ZONING CONDITIONS FOR THE MERRITT RESERVE

CONSTRUCTION DRAWINGS FOR MERRITT RESERVE

PROJECT NUMBER = CID-25-XX

JOB NUMBER: 23-0004
 CHECKED BY: BH
 DRAWN BY: DH/RC/SM/GE/MA/LL/JB
 DATE: 05/01/2025
 SHEET TITLE:
UTILITY PLAN OVERALL
 SHEET NO.:
CU-100

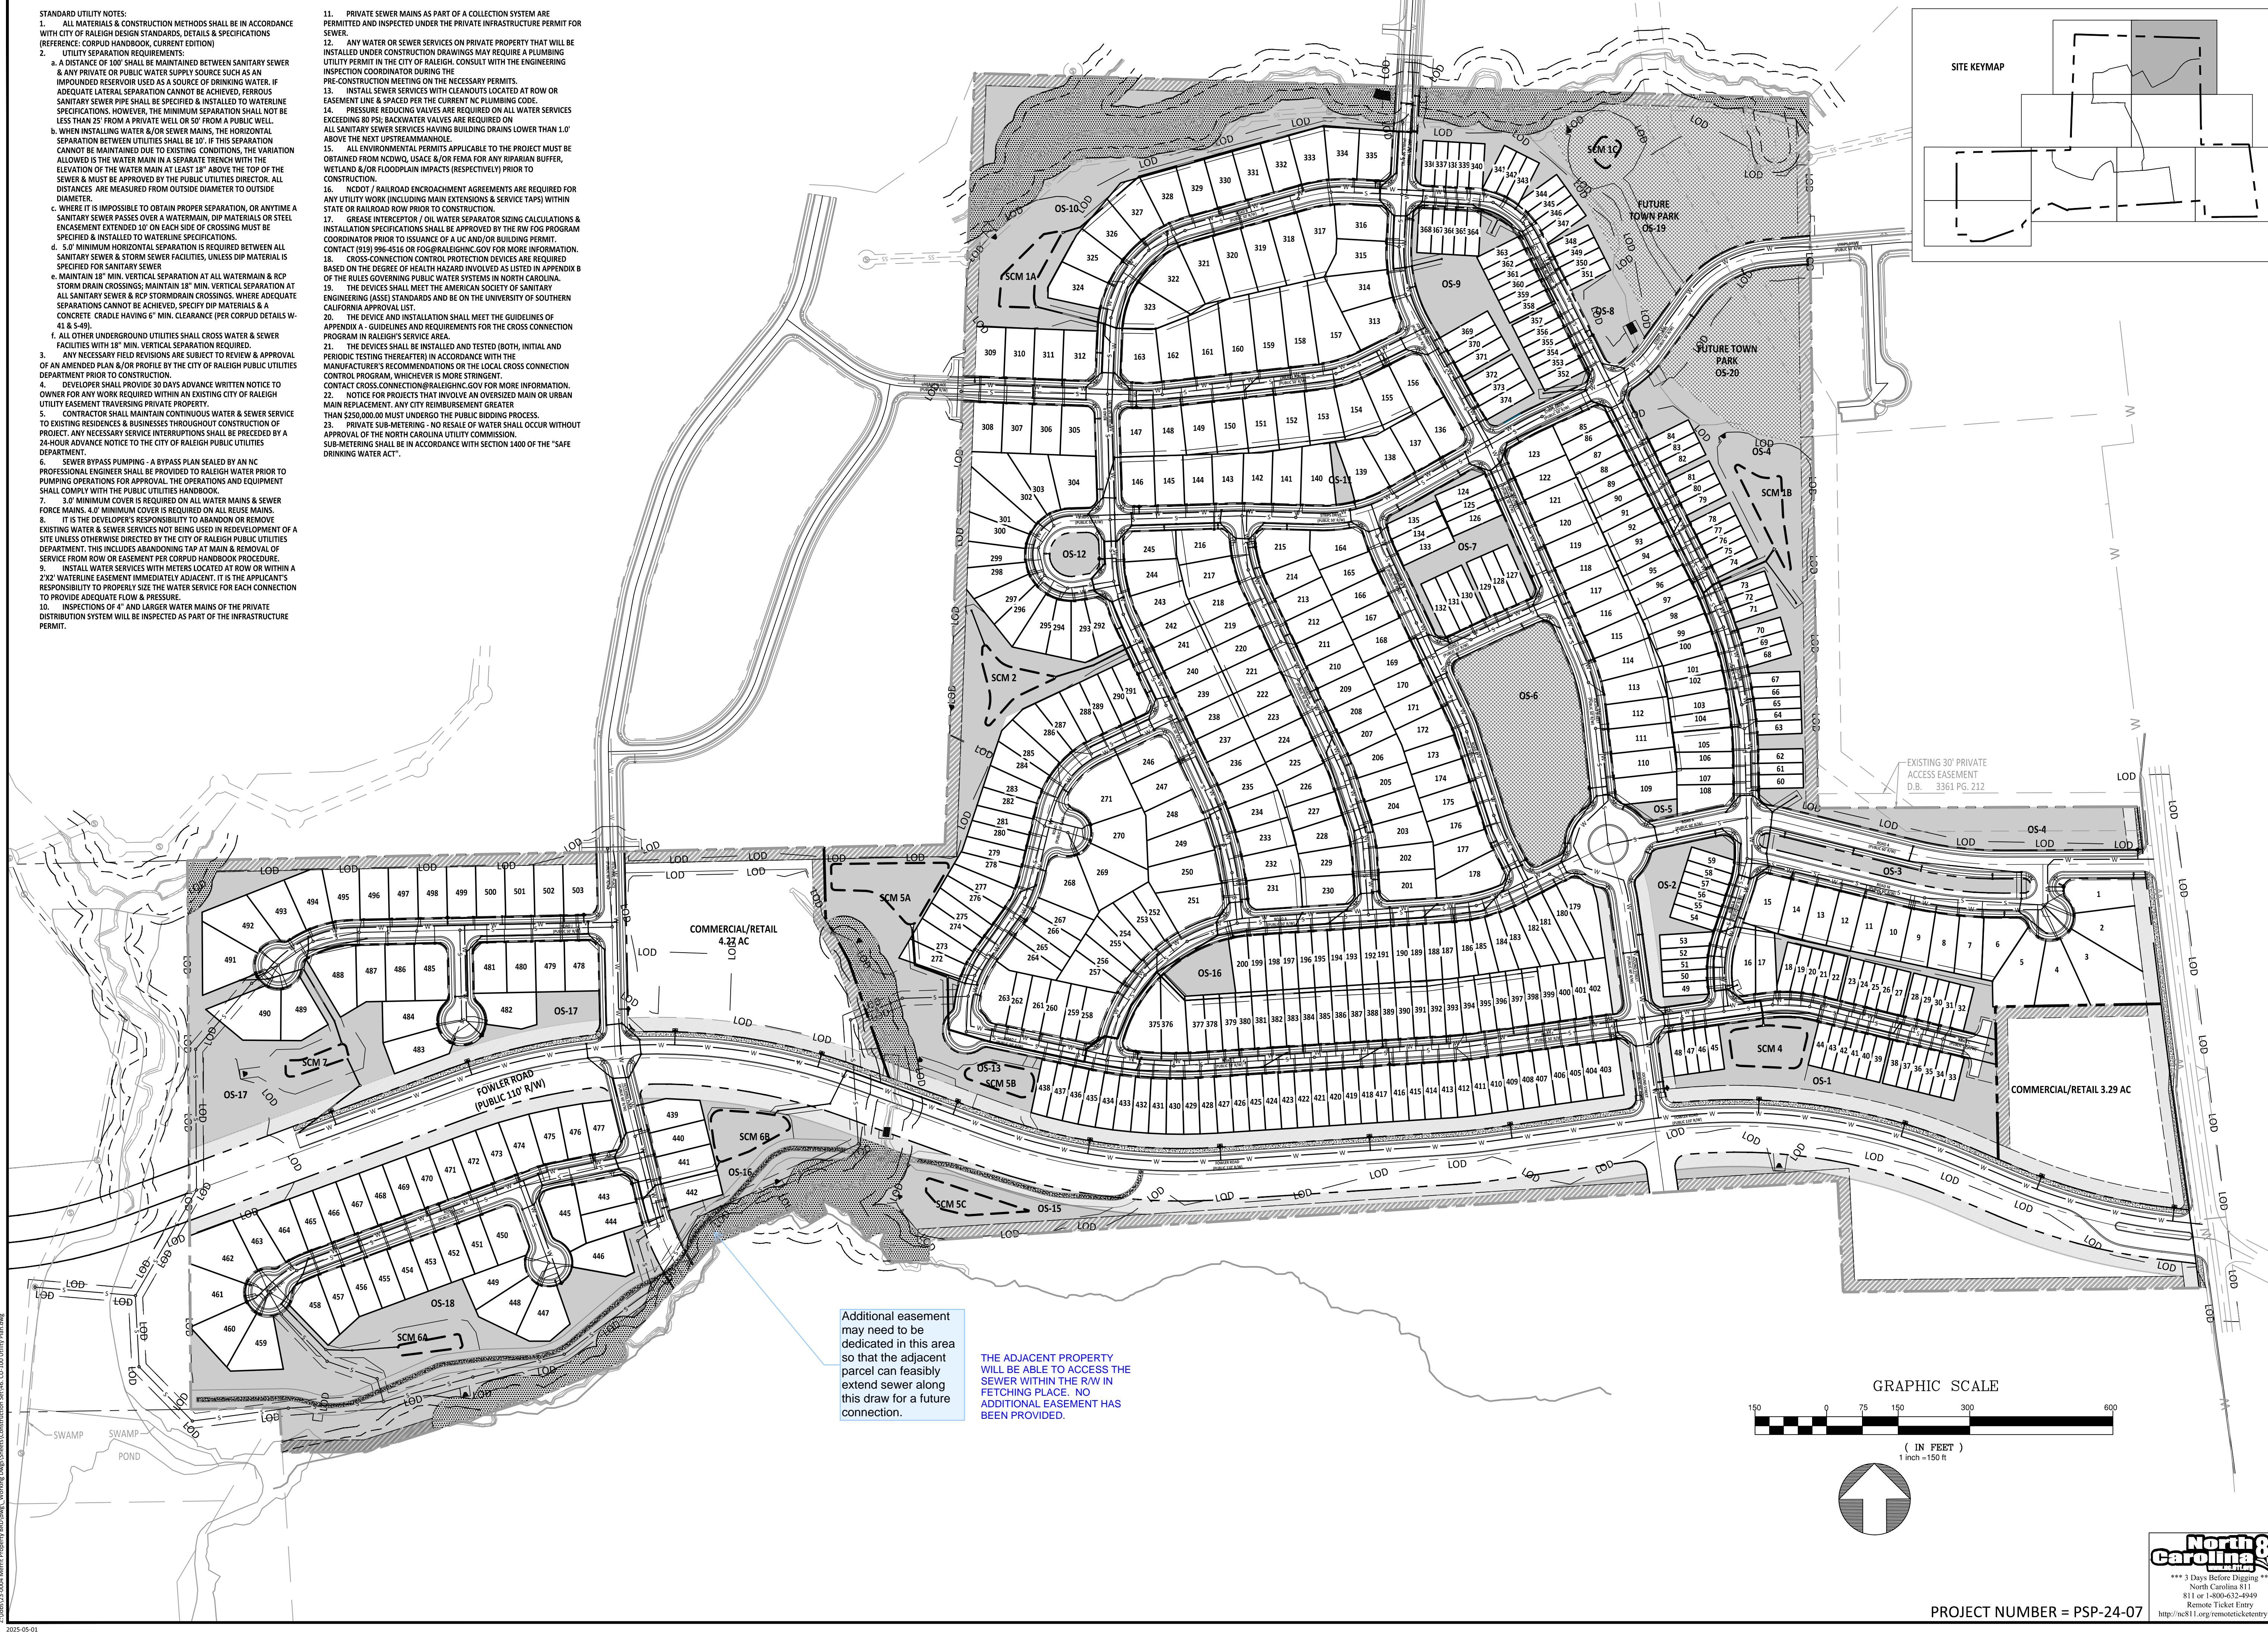
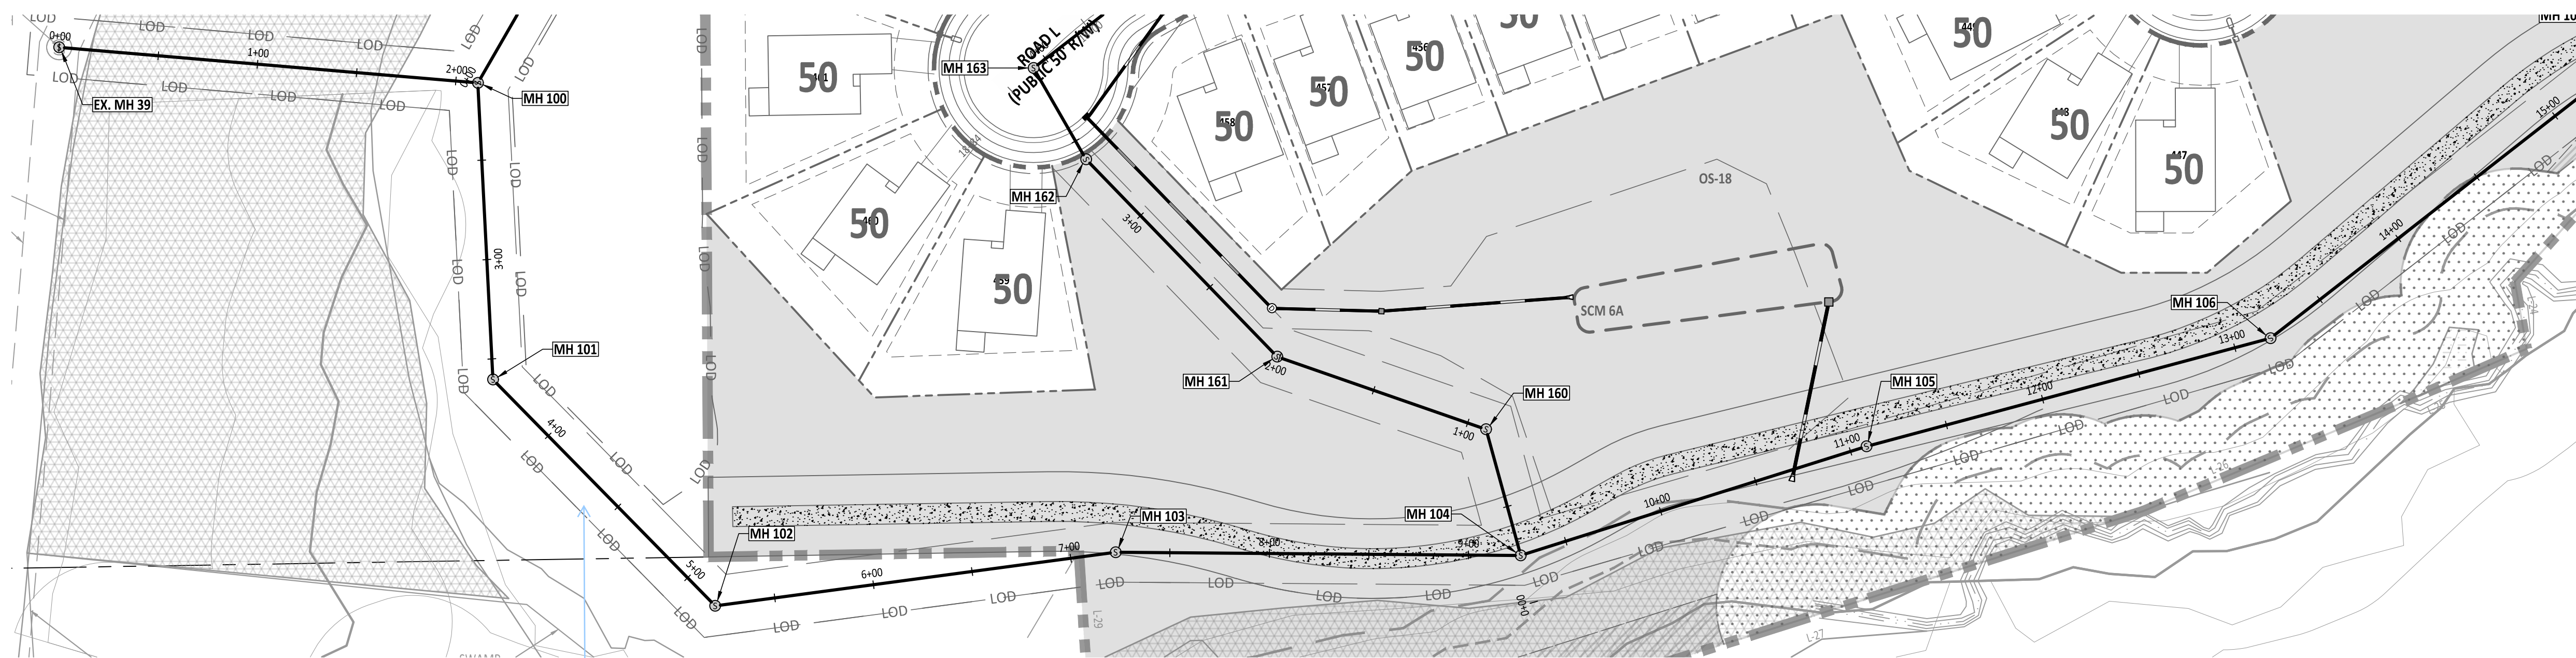
Additional easement may need to be dedicated in this area so that the adjacent parcel can feasibly extend sewer along this draw for a future connection.

These offsite easements must be recorded prior to CD approval.

THE ADJACENT PROPERTY WILL BE ABLE TO ACCESS THE SEWER WITHIN THE R/W IN FETCHING PLACE. NO ADDITIONAL EASEMENT HAS BEEN PROVIDED.

NOTED.

CU-200 PLAN & PROFILE

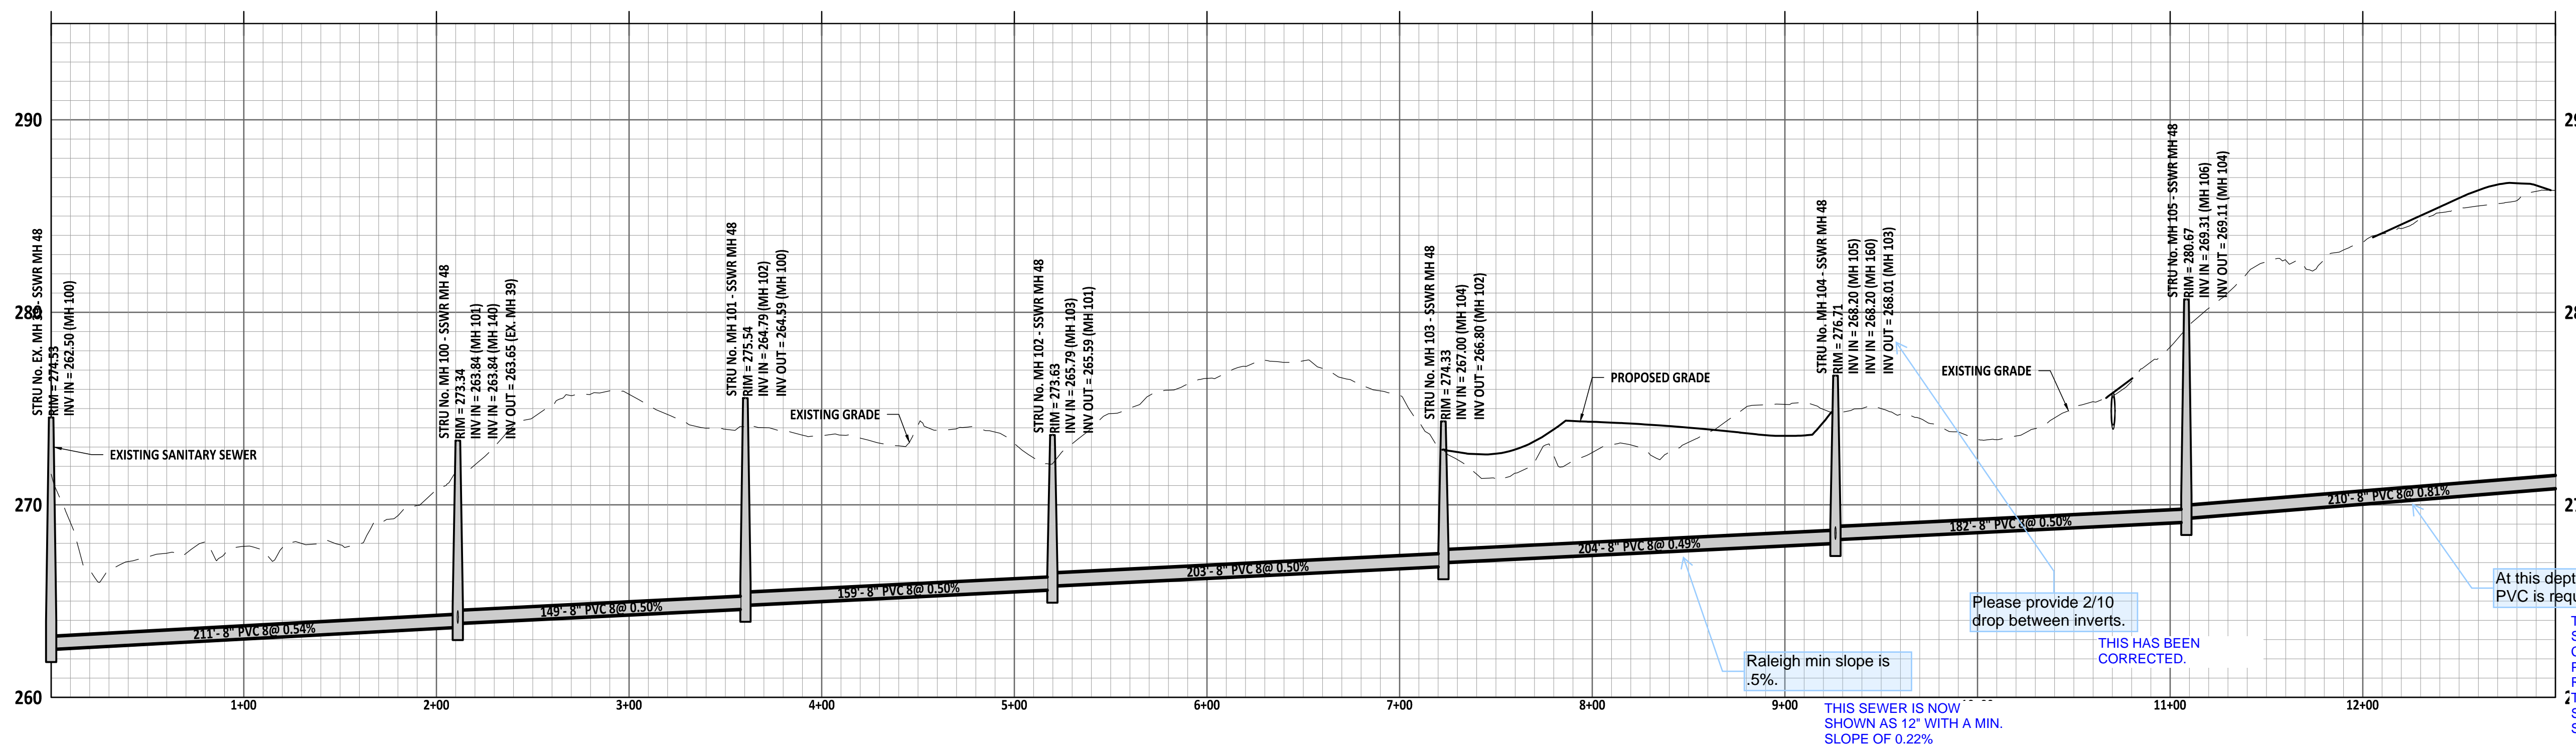
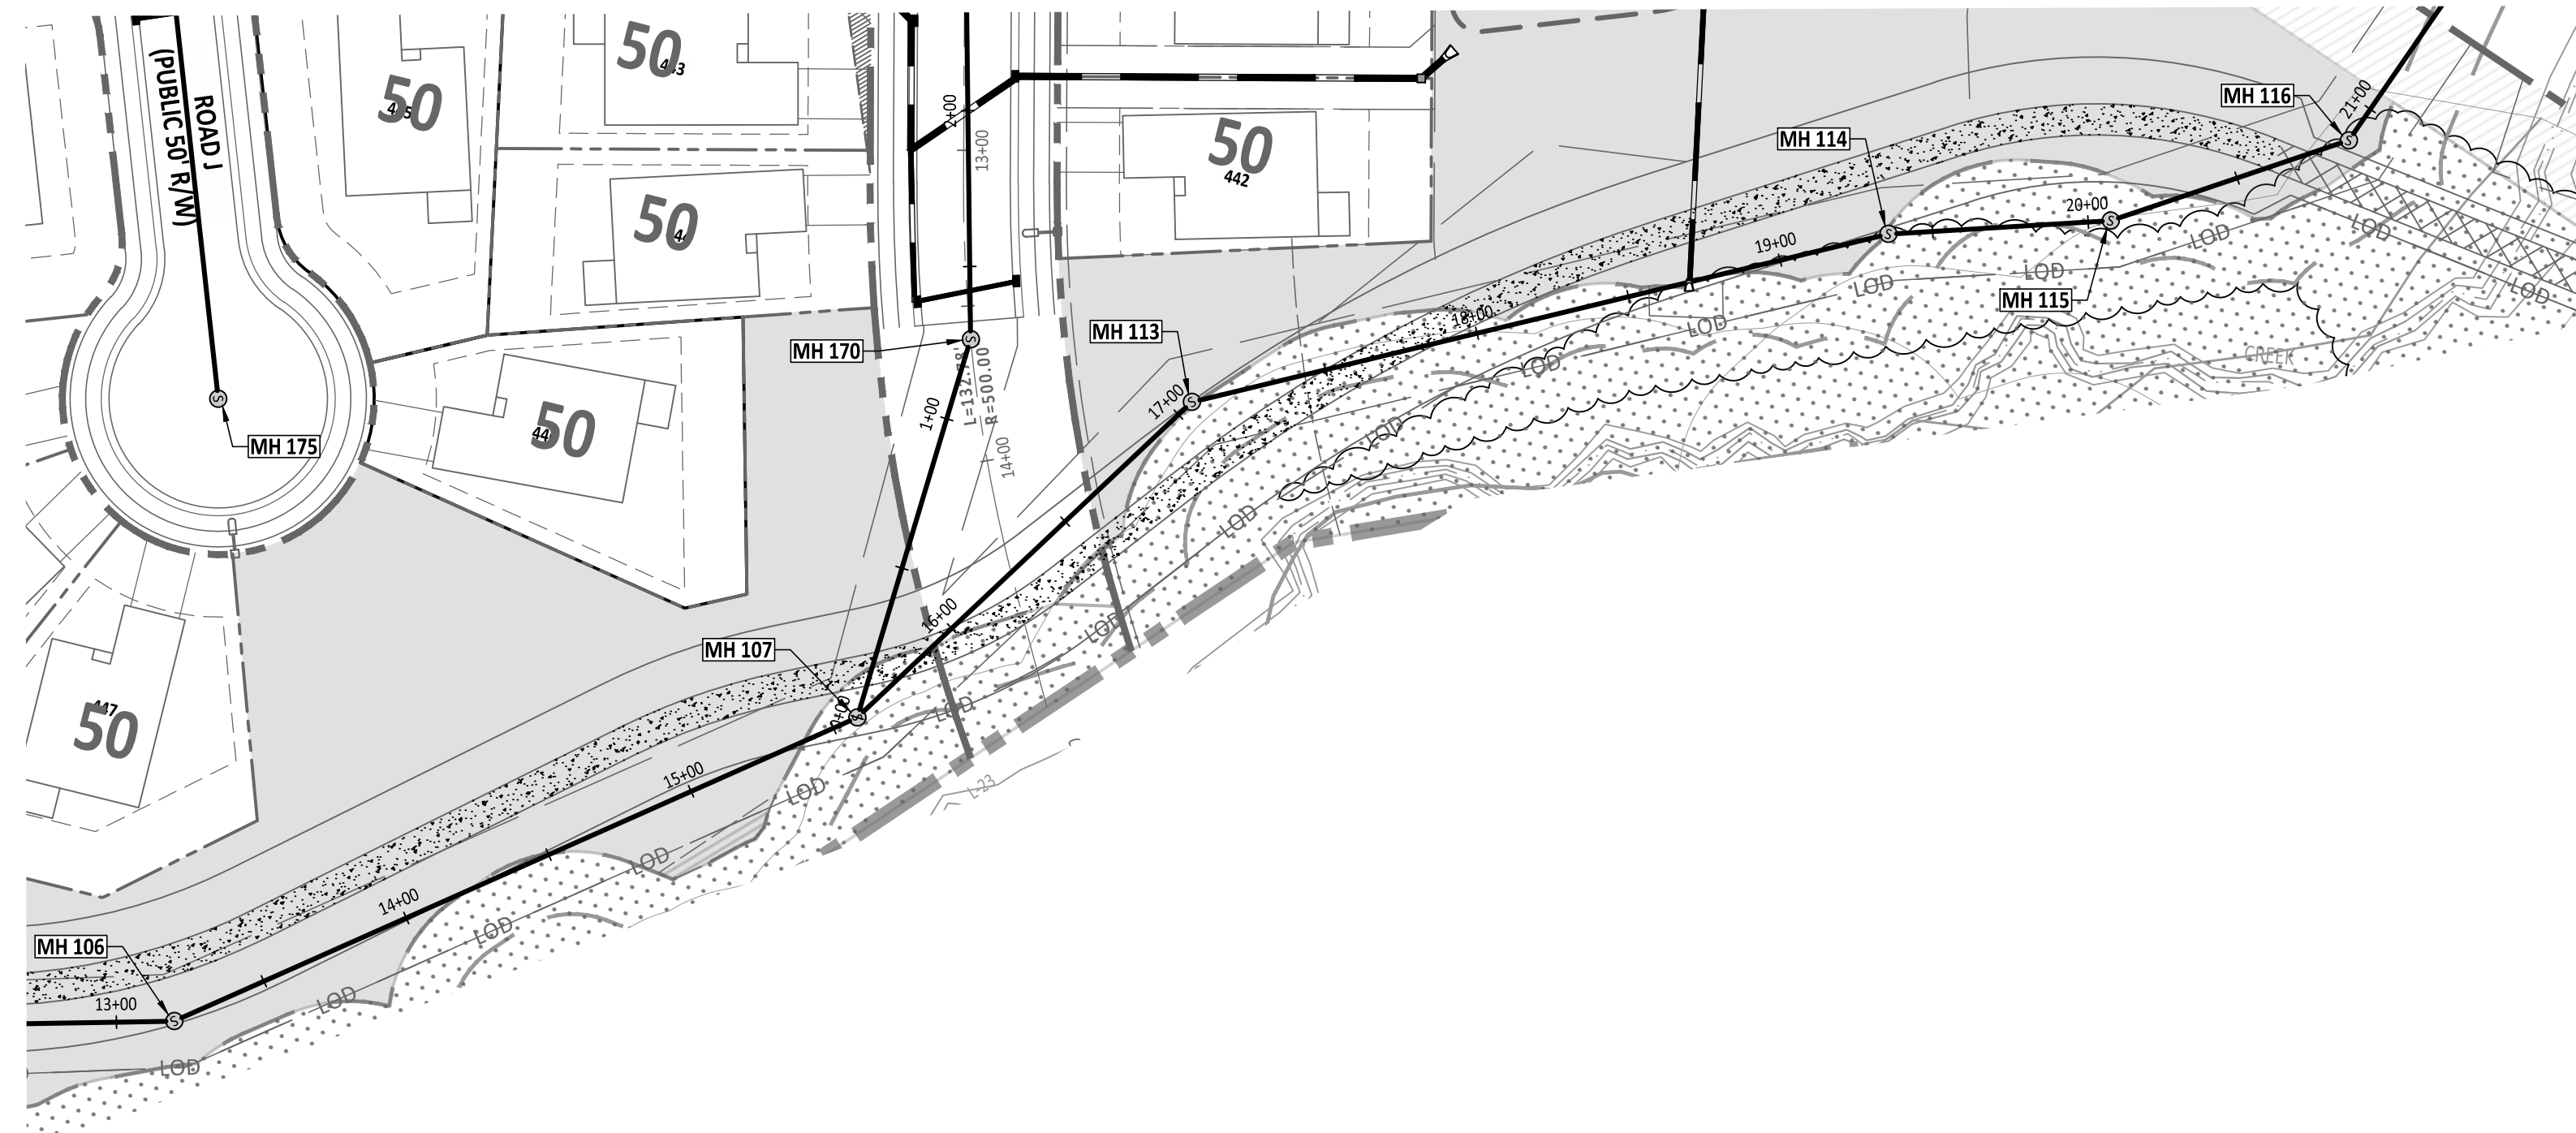
Raleigh min slope is .5%

Please provide 2/10 drop between inverts.

At this depth SDR 26 PVC is required.

THIS HAS BEEN CORRECTED.

THIS WILL BE CORRECTED SEPARATELY. WE ARE CURRENTLY GOING THROUGH POSSIBLE LAYOUT CHANGES TO REDUCE COST OF THE PROJECT. THE MATERIAL AND MANHOLE SIZES WILL BE UPDATED WHEN SEWER DESIGN IS FINALIZED.
